GLOBAL SAFETY FIELD INVESTIGATIONS
DCS6111
URGENT - DISTRIBUTE IMMEDIATELY

Subject: REVISION: N212338810-01 - Service Update
Body Mount Stress Concentration, Noise, Rattle
New Expiration Date

Models: 2016-2019 Chevrolet Suburban HD
Equipped with 6.0 Gasoline Engine (RPO L96) and Flt Government
Vehicle (RPO GAM)

N212338810 Body Mount Stress Concentration, Noise, Rattle

5937183

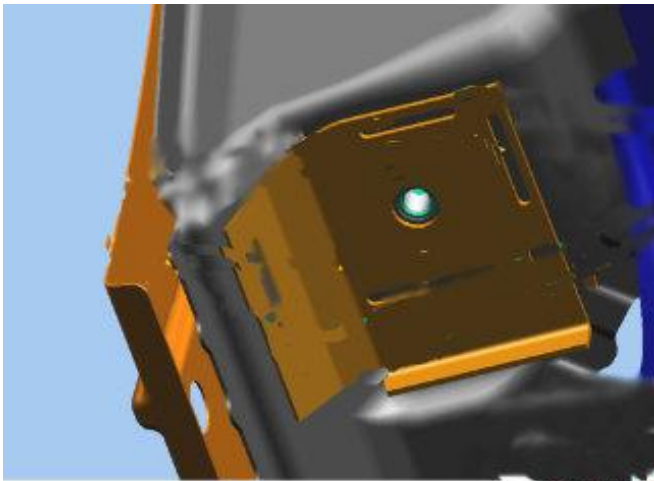
3. Remove the left body mount in front of the rear wheel. Refer to *Body Mount Upper and Lower Cushion Replacement* in SI. There is a rubber cone shaped sleeve in this mount, it can be discarded, it is an assembly aid at the plant.

5937190

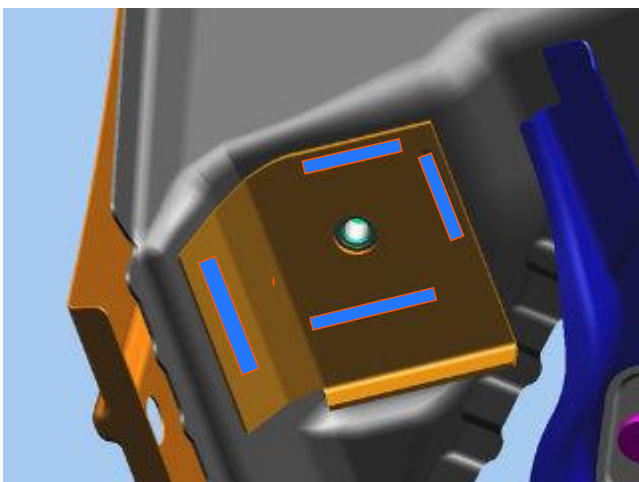
5. Position the reinforcement against the underbody as shown. Center the hole in the reinforcement to the body mount bolt hole.

6. Install a suitable nut on the body bolt approximately 25mm (1.0 in.) from the bolt tip. As an alternative, a small section of pipe and a washer can be used as shown in the graphic.
7. Install the bolt/nut assembly to fixture the reinforcement to the underbody.

5937198

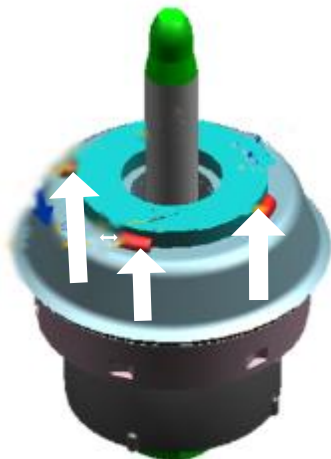
12. Reinstall the reinforcement using the bolt and nut combination. Ensure the hole in the reinforcement is centered to the body mount bolt hole.

13. MIG stitch weld the four slots in the reinforcement to the underbody. Weld 20mm lengths at a time to control the heat, alternate between the 4 slots.
